UNITED STATES
NUCLEAR REGULATORY COMMISSION
WASHINGTON, D.C. 20555-0001

SAFETY EVALUATION BY THE OFFICE OF NUCLEAR REACTOR REGULATION
RELATED TO AMENDMENT NO. 229 TO FACILITY OPERATING LICENSE NO. DPR-28
ENTERGY NUCLEAR VERMONT YANKEE, LLC
AND ENTERGY NUCLEAR OPERATIONS, INC.
VERMONT YANKEE NUCLEAR POWER STATION
DOCKET NO. 50-271

Fig. 1: Vermont Yankee RELAP5 Nodalization

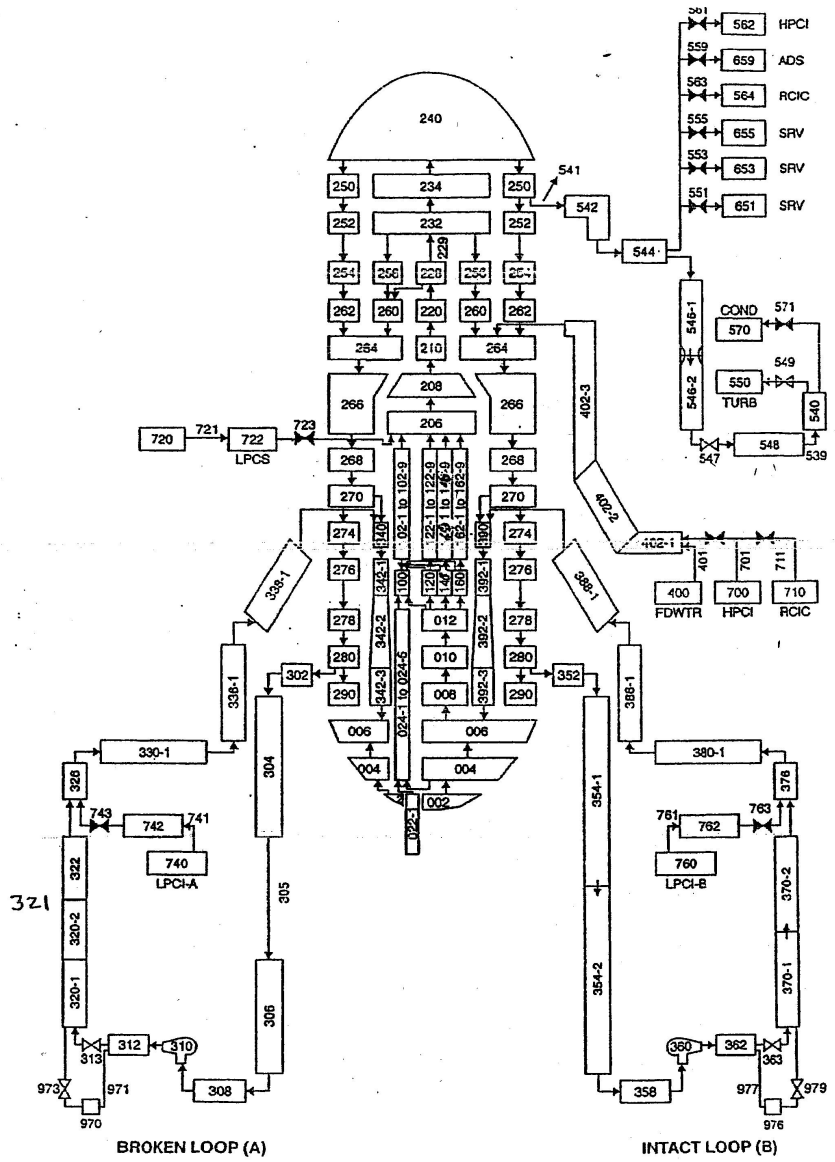
Figure 1 presents the RELAP5/MOD3 model of the VYNPS NSSS. As stated above, the RELAP5/MOD3 deck obtained from the licensee was modified to reflect the higher power level and the GE-14 fuel design.

Fig. 2: Break Mass Flow Rate vs Time

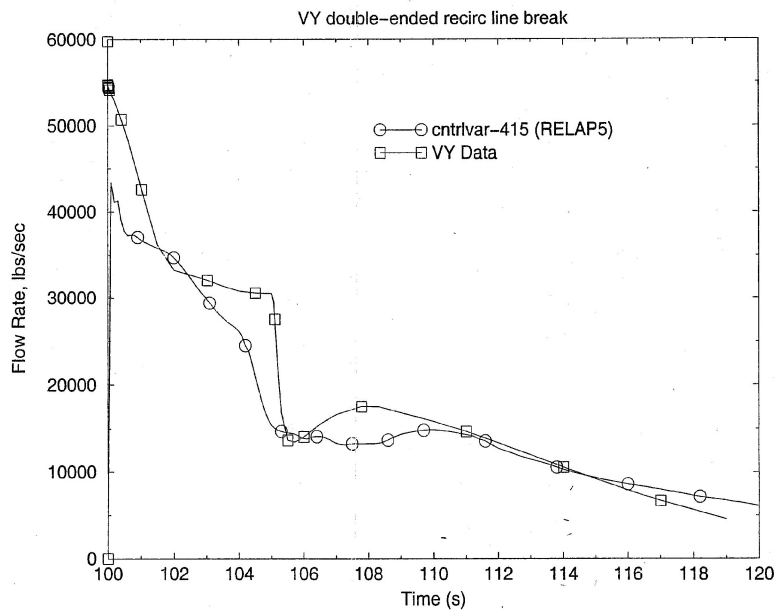
Figure 2 presents the mass flow rate from the break in the suction line. This flow rate consists of the break flow exiting both sides of the double-ended guillotine break in the recirculation line. To model the double-ended break, the break junctions are located at the exit to volume 304 and the inlet to volume 306 in Figure 1. The Henry-Fauske critical flow model in the RELAP5/MOD3 code was activated to predict the break flow. Inspection of Figures 2 and 3 shows that the RELAP5 code confirms the conservative nature of the VYNPS calculation at EPU conditions.

Figure 2.8.7-7
Void Reactivity Coefficient vs. Instantaneous Void Fraction at an Exposure of 0 GWd/t

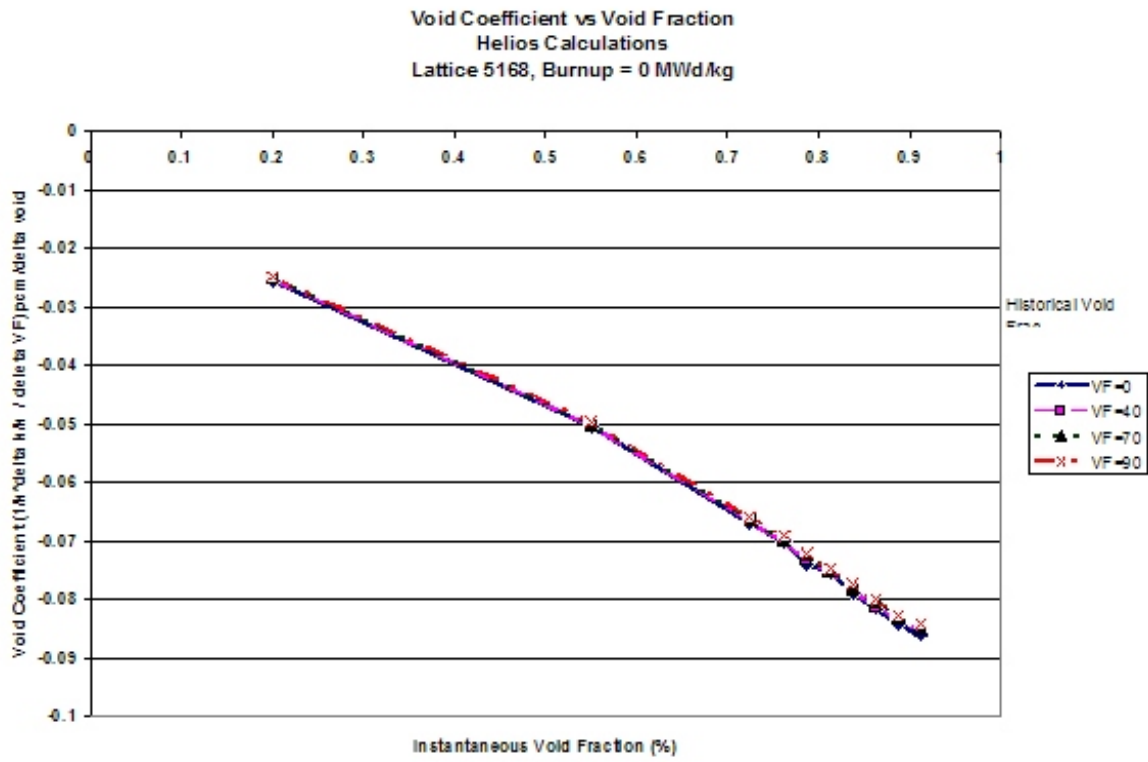
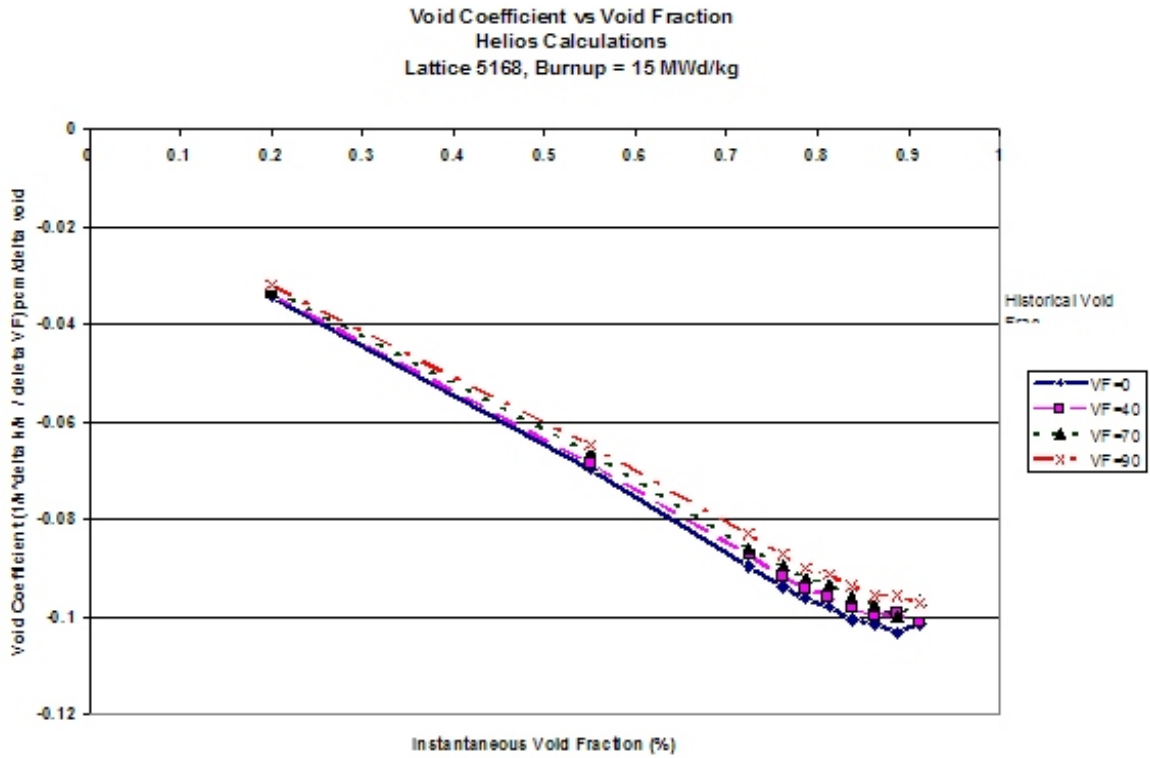
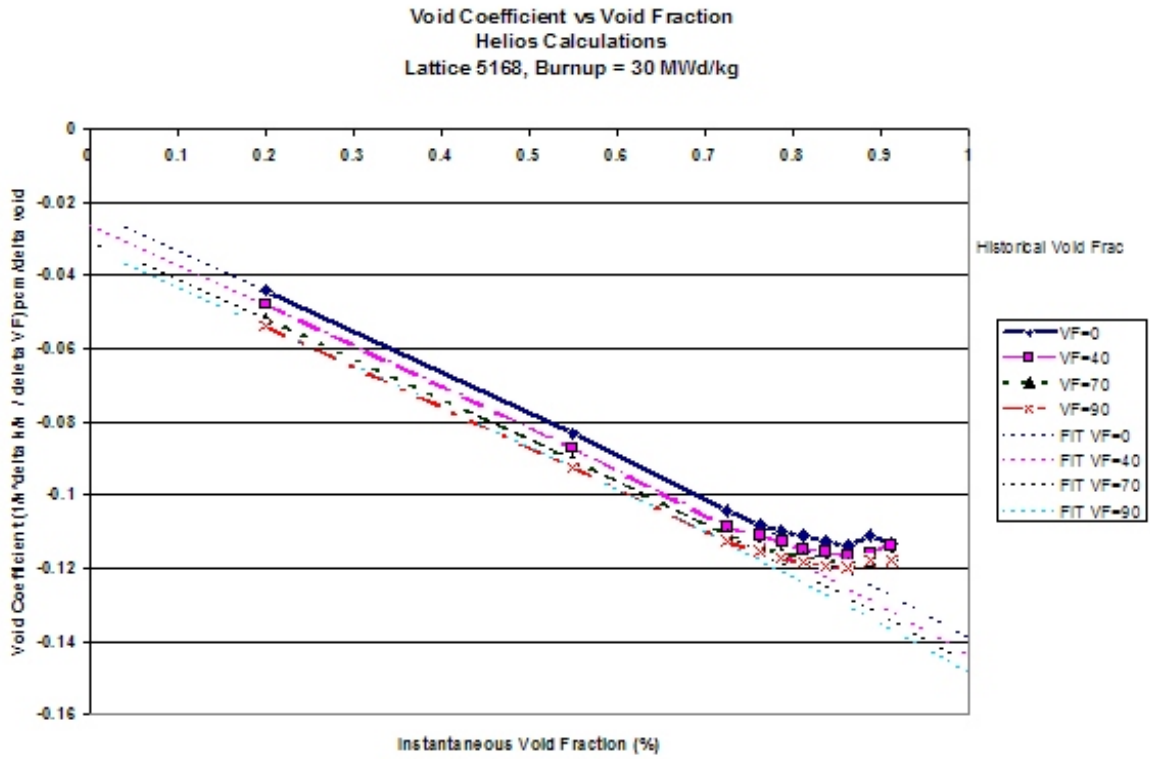
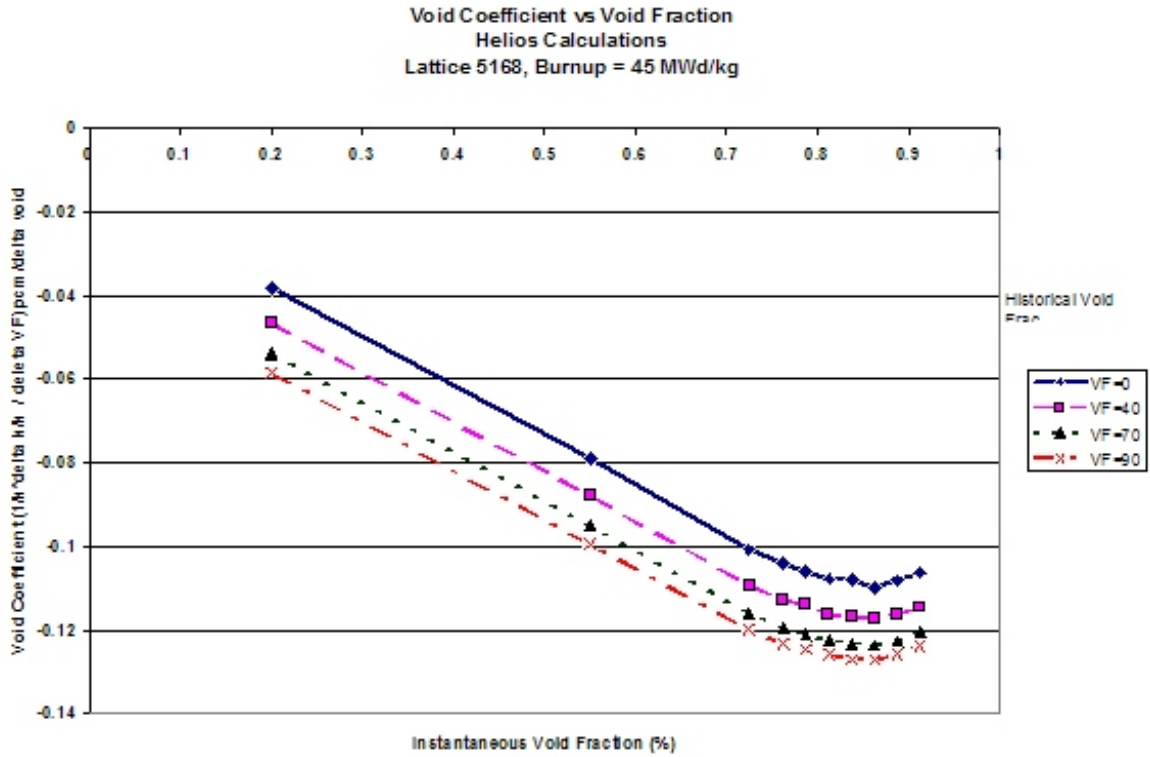
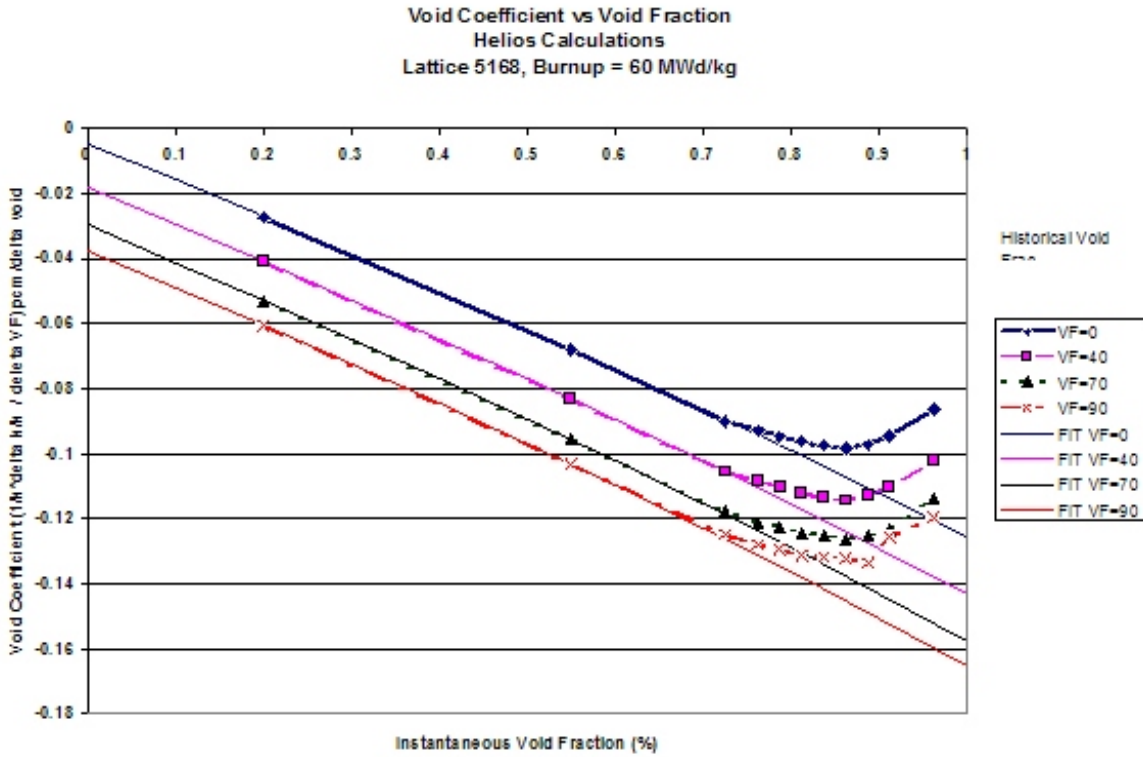
Comparisons of the void reactivity coefficients for the different void history cases and exposures are presented in Figures 2.8.7-7 through 11. Note that additional instantaneous branch points were calculated at the higher void conditions to resolve the non-linearity of the void coefficient with respect to instantaneous void fraction at high burnups. The impacts of the different void histories are evident at the higher void fractions with the increasing differences in the void reactivity profiles with increasing exposure (see Figure 2.8.7-11, for example). The difference in the profiles from that at a void history of 40% represents a potential error resulting from GE's methodology. In addition, the deviation of the void reactivity from a linear variation represents an error that results from the quadratic extrapolation used in GE's methodology. As shown in these figures, at high void fractions and high exposures the profile deviates from linear.

void branches only at 40% void history) against void reactivity coefficients calculated at different void histories with exposure. A plot showing the potential errors is presented in Figures 2.8.7-7 through 2.8.7-11. These figures show that the fitting process results in increasing errors with exposure and burnup (as previously discussed, based on the void reactivity coefficient plots). The errors for exposures of about 30 GWd/t and less are consistent with the [[]] uncertainty assumed in the ODYN analysis. However, for higher exposures at high void fractions the error increases to more than 30%.

Figure 2.8.7-19
Comparison of TGBLA-6 and CASMO-4 Kinf Values for Lattice 6996

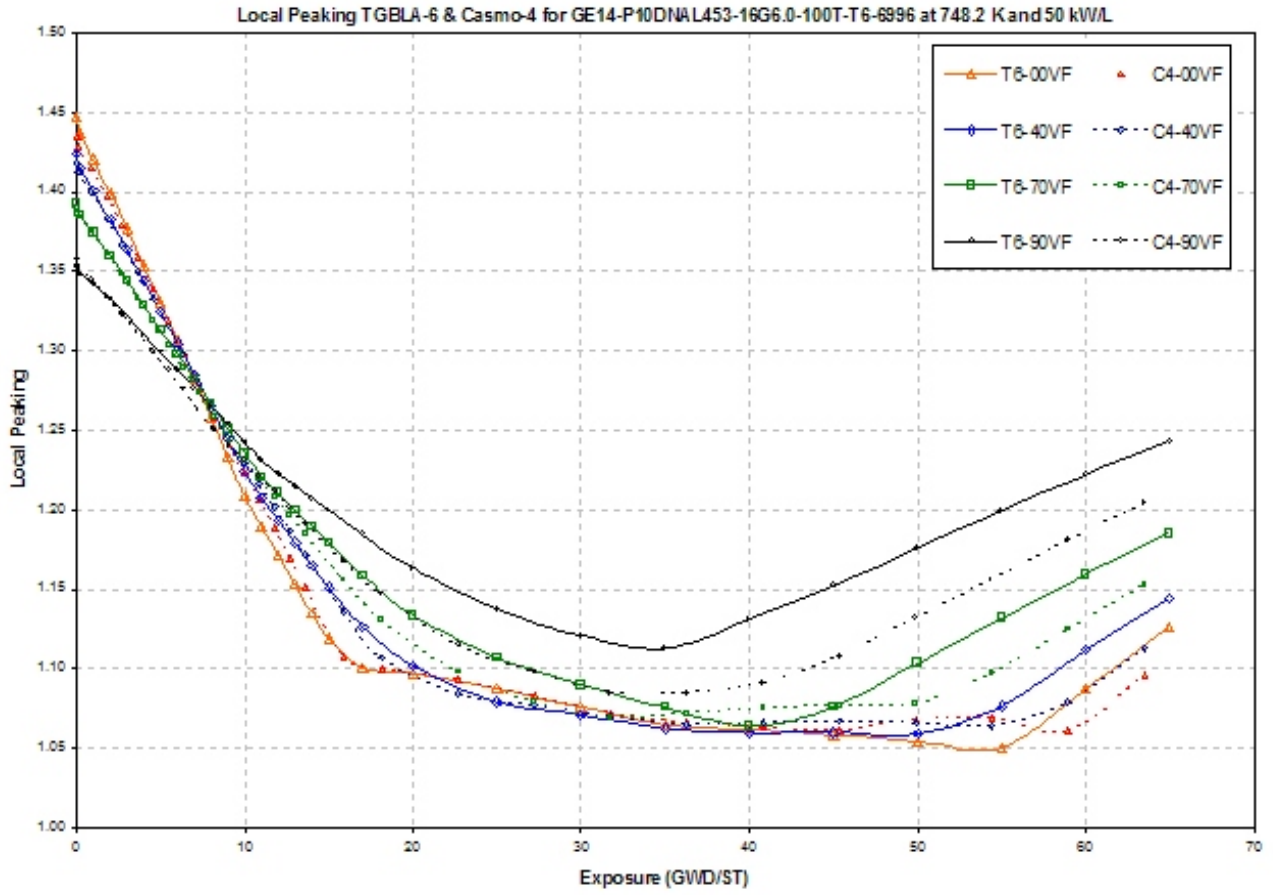
Figures 2.8.7-19 and 2.8.7-20 provides two K_{inf} vs. exposure curves for historical void fractions of 40% and 70%. The calculations were performed with an instantaneous void fraction of 0%. Therefore, the difference at high exposure is caused by differing isotopic compositions resulting from the depletion at different void histories. As these figures show, the impact of void history at high exposures is significant (greater than 5% delta k). Confirmatory analyses performed with HELIOS, presented in Figure 2.8.7-21, show a similar trend and include data for a historical void fraction of 90%.

Figure 2.8.7-22
Comparison of TGBLA-6 and CASMO-4 Local Peaking for Lattices 6996

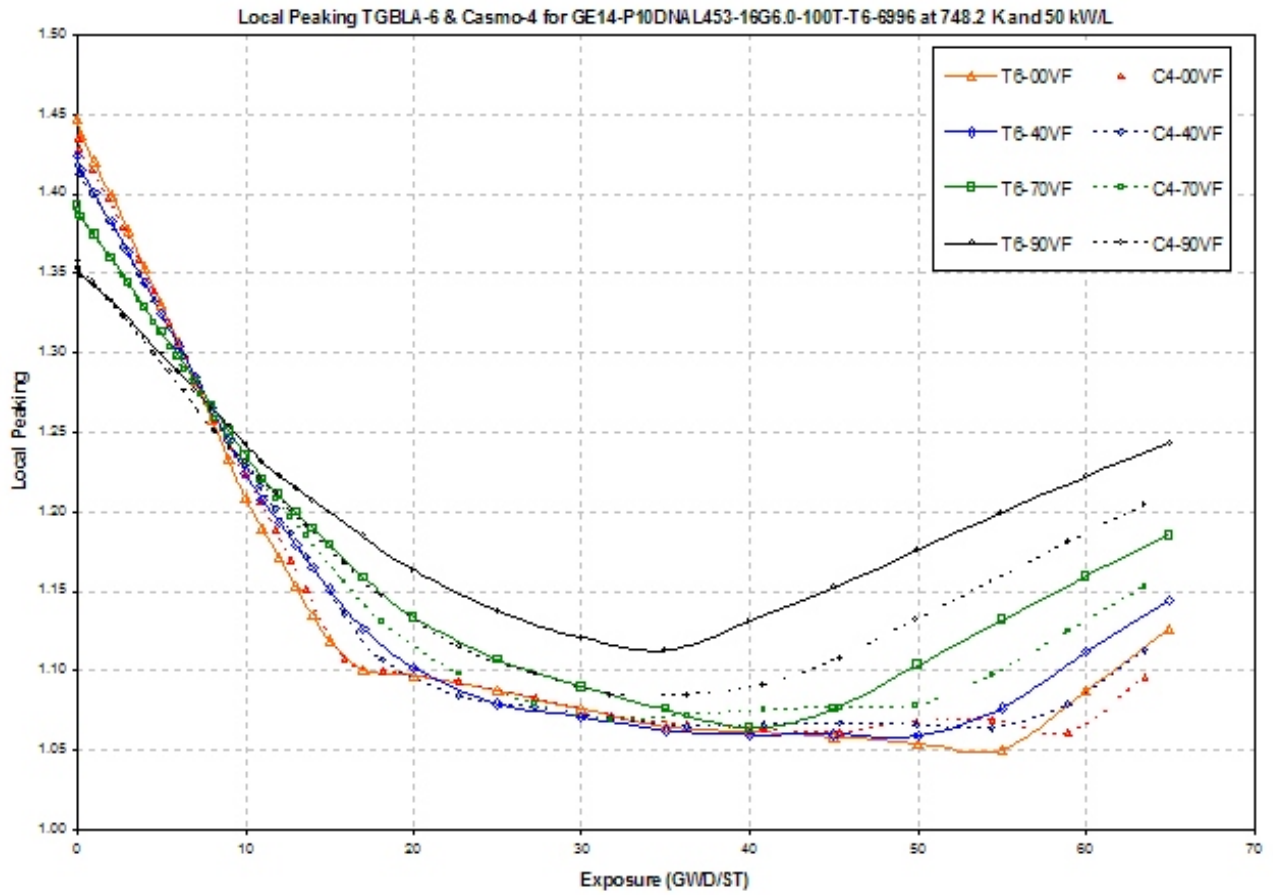
The pin peaking factor (Figure 2.8.7-22) shows good agreement at zero exposure, when the power peaking is the most significant. Differences increase with exposure resulting in several percent at burnups of 60 GWd/ST. Generally, the TGBLA-6 local peaking factors are larger than CASMO-4 and therefore will be more conservative in regards to pin exposure and LHGR. Note that at high exposures (greater than 30 GWd/ST), the power peaking is the largest for bundles with the highest void history. However, given that the power generation in this highly burned fuel is low, the net result is that the overall LHGR (a product of the region average power and the local power peaking) will be lower than that earlier in the exposure history, where the differences are smaller. However, the LHGR limit is lower at higher fuel exposures. Therefore, if spectral shift strategy is employed, as proposed in the expanded operating domains for EPU plants, with the upper nodes depleting at high void conditions and a top-peaked power distribution, both the bundle power and the pin power peaking would be high, at the most limiting kW/ft exposures.

Figure 2.8.7-23
TGBLA-6 / CASMO-4 RMS of Lattice Pin Power Peaking

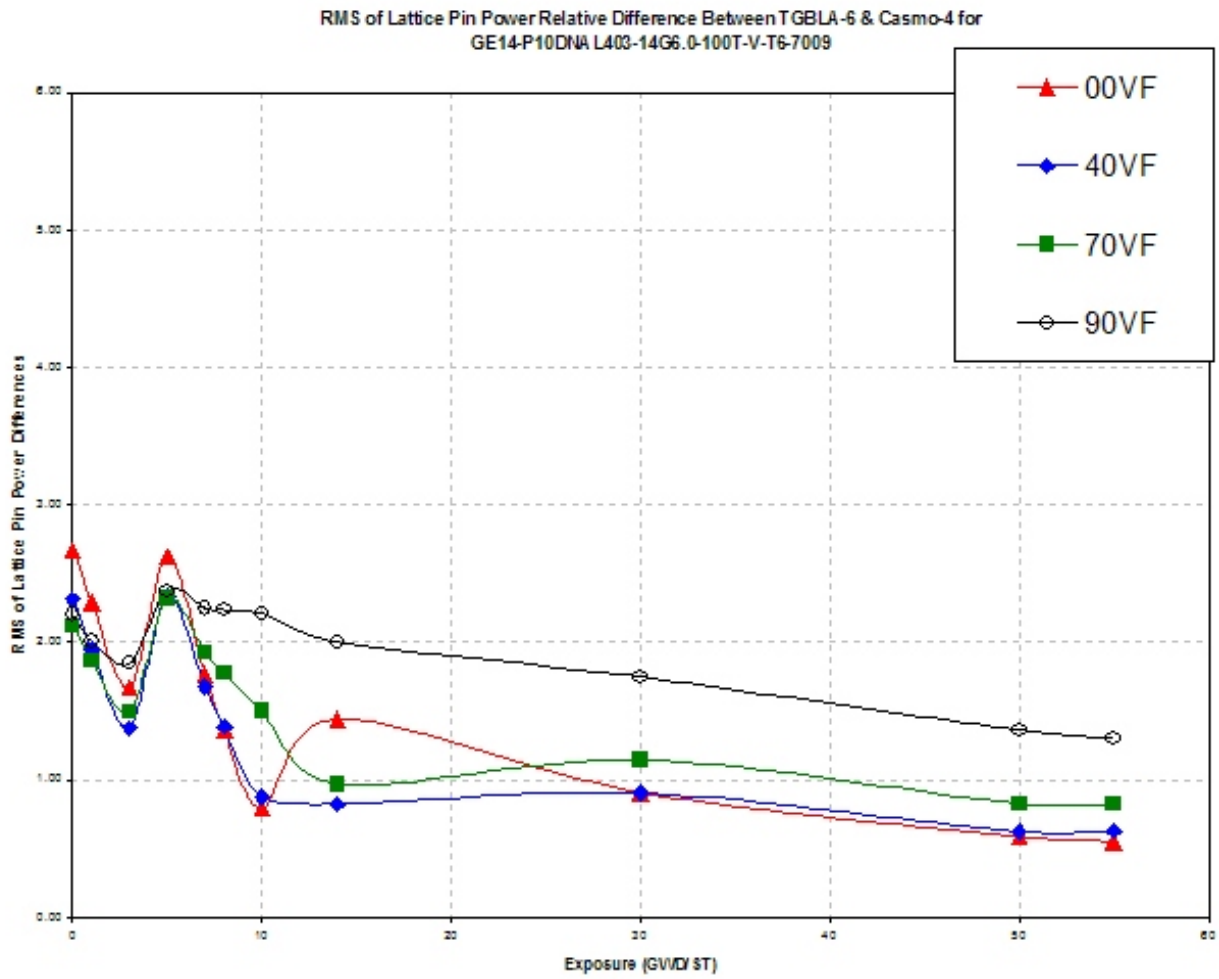
Figure 2.8.7-23 shows the root-mean-square (RMS) of the differences between TGBLA-6 and CASMO-4. The RMS error is used in development of the SLMCPR. Previous analysis comparing TGBLA-6 and MCNP (Reference 69, Enclosure 3) had shown that for a variety of lattices and exposures, that the RMS difference is [[]]. However, in these comparisons the isotopic concentrations were taken from TGBLA and used in MCNP and, therefore, errors in depletion were not included. The results in this figure show that on a code-to-code basis that, for the lower void fractions, the RMS difference at low exposures and at high void fraction exceeds the [[]] RMS value, with maximum differences of about 2.5%. For the burnups above the gadolinium burnout and for lower void fractions, the differences are consistent with the [[]] value. Note that the results for the 90% void fraction presented in Figure 2.8.7-23 does not include potential errors caused by the quadratic fit and extrapolation used in GE's
